Before the Hearing Commissioner Appointed by Canterbury Regional Council and Selwyn District Council

In the matter of an application by Southern Screenworks Limited for land use

consents and discharge permits associated with the extension of, and changes to, existing quarry operations at 50 Bealey

Reply statement of evidence of Kevin Michael Bligh

Plan Appendix CRC244887: Glasson Huxtable Landscape Mitigation Plans 2.0, 3.0 and 4.0

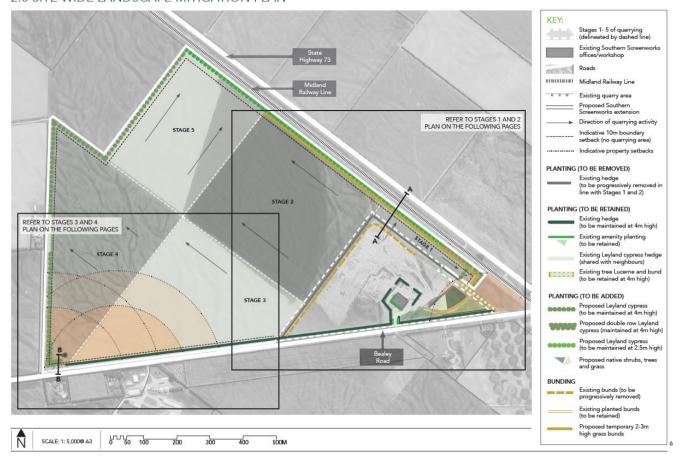
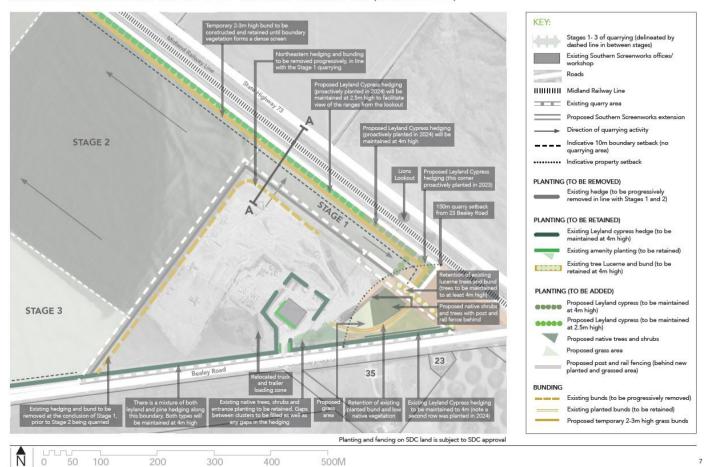
j.	Rehabilitation of completed sections of the quarry as soon as practicable to minimise the potential for dust emissions and to meet the open area limited defined in <u>Ceondition (5)</u> .	
bounda m of the and 15 Glasso Pages Limited This lim from th written Region	ation must not be undertaken within 150 m of the notional ary of the principal residential unit at 23 Bealey Road and 200 e notional boundary of the principal residential units at 137 as Bealey Road as shown on Plan in Appendix CRC244887: In Huxtable Landscape Mitigation Plans 2.0, 3.0 and 4.0 and 5, 7 and 8, April 2025, Revision 3 Southern Screenworks I Aylesbury. Initiation shall not apply if written approval has been obtained e owners and occupiers of the respective residential unit. If approval is obtained, this shall be provided to the Canterbury al Council, Attention: Compliance Manager at least 20 g days prior to starting works in this area.	The wording has been updated to reflect the latest figures which show the bund has been removed following Mr Coleman's evidence. The use of an Appendix is also consistent with the approach proposed by the s42A Officer in CRC244890. A revised set has been prepared and figures updated at the back of these consents.

shown <u>Mitigati</u>	ate processing shall not occur within Stages 3 and 4 as in Plan Appendix CRC244887: Glasson Huxtable Landscape on Plans 2.0, 3.0 and 4.0 Pages 6, 7 and 8, April 2025, on 3 Southern Screenworks Limited Aylesbury.	The wording has been updated to reflect the latest figures. The use of an Appendix is also consistent with the approach proposed by the s42A Officer in CRC244890. A revised set has been prepared and figures updated at the back of these consents.
Prior to	Commencement of Works	
describ Canterl	t 20 working days prior to the commencement of activities led in Condition (1), the consent holder must inform the bury Regional Council, Attention: Compliance Manager (via @ECan.govt.nz) in writing of the date of commencement of the comm	-

4.0 LANDSCAPE MITIGATION PLAN - STAGES 3.0 AND 4.0 (ZOOMED IN)

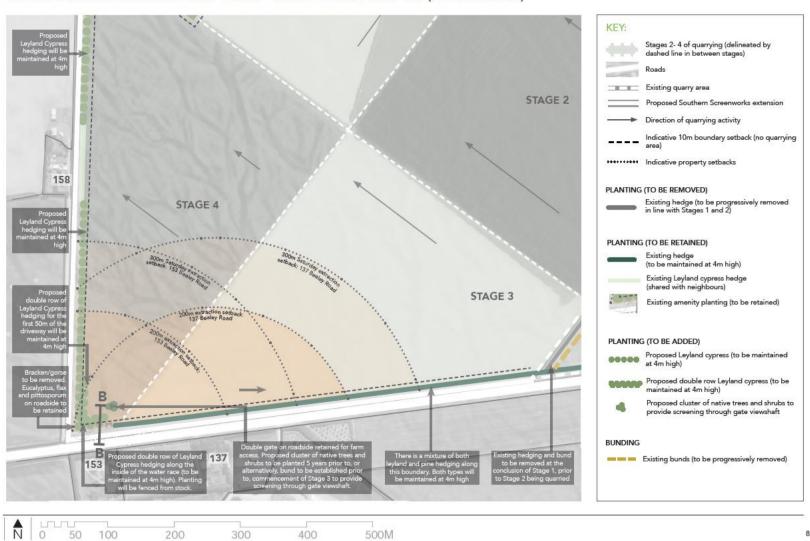
- (c) remove bunding from the south-western corner of the site in light of Mr Coleman's evidence that it is not required to address his concerns, and the evidence of all experts to the effect that it is not necessary;

- (d) make it clear when planting or bunding in the south-western corner of Stage 4 should be undertaken;

16.	 48. At least 5 years prior to extraction activities commencing within Stage 3, the consent holder shall: a) Plant and maintain a cluster of native trees; or 	Clarifies what is proposed in the south-west corner of the site and by when it is has to occur.

b) Establish and grass a 2-3 m high bund	
	in the southwest corner of Stage 4 in accordance with the Glasson Huxtable Landscape Mitigation Plan 4.0, Page 8, Southern Screenworks Limited Aylesbury referenced in Condition 1.

in the southwest corner of Stage 4 in accordance with the *Glasson Huxtable Landscape Mitigation Plan 4.0, Page 8, Southern Screenworks Limited Aylesbury* referenced in Condition 1.
